Access Compliance Report

Public Rights-of-Way

(Curb Ramps)

Intersection ID: 4850	Main Street: HARRINGTON_WOODS_RD	Cross Street: W_W_T_HARRIS_BV	Location: SW
ADA ID: 337755CD043A	Ramp Type: Perp	Initial Pass/Fail: Fail	Overall Compliance: No
Severity Score: 12.5			
Codes/Mitigation Info/Possible Solution		Field Measurements/Component Compliance

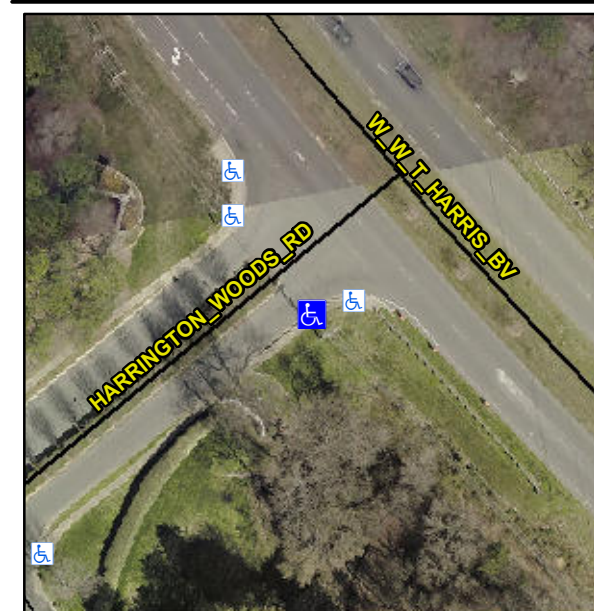
Not Found, R304.2.2

Compliance	Description	Data	Compliance	Description	Data
N/A	Ramp Length (in)	48.0	No	Ramp Slope (%)	8.7
Yes	Ramp Width (in)	48.0	Yes	Ramp XSlope (%)	1.6
N/A	Flare Type LT	N/A	N/A	Flare Type RT	N/A
N/A	Flare Slope LT (%)	N/A	N/A	Flare Slope RT (%)	N/A
N/A	Flare Traversable LT?	N/A	N/A	Flare Traversable RT?	N/A
N/A	Landing Length (in)	N/A	N/A	DWS Provided?	N/A
N/A	Landing Width (in)	N/A	N/A	DWS Contrast?	N/A
N/A	Landing Slope (%)	N/A	N/A	DWS Length (in)	N/A
N/A	Landing X Slope (%)	N/A	N/A	DWS Full Width?	N/A
N/A	Landing Curb? (Y/N)	N/A	N/A	DWS Offset (in)	N/A
N/A	Shared Landing?	N/A			
N/A	Gutter Ponding?	N/A	N/A	Gutter Slope (%)	N/A
N/A	Gutter Lip Ht (in)	N/A	N/A	Gutter X Slope (%)	N/A
N/A	Painted X Walk1?	No	N/A	Painted X Walk2?	N/A
	X Walk 1 Direction	To NW		X Walk 2 Direction	N/A
N/A	X Walk 1 Width (in)	N/A	N/A	X Walk 2 Width (in)	N/A
	X Walk 1 Slope (%)	3.8		X Walk 2 Slope (%)	N/A
	X Walk 1 X Slope (%)	2.6		X Walk 2 X Slope (%)	N/A

Remove & Replace Entire Ramp.
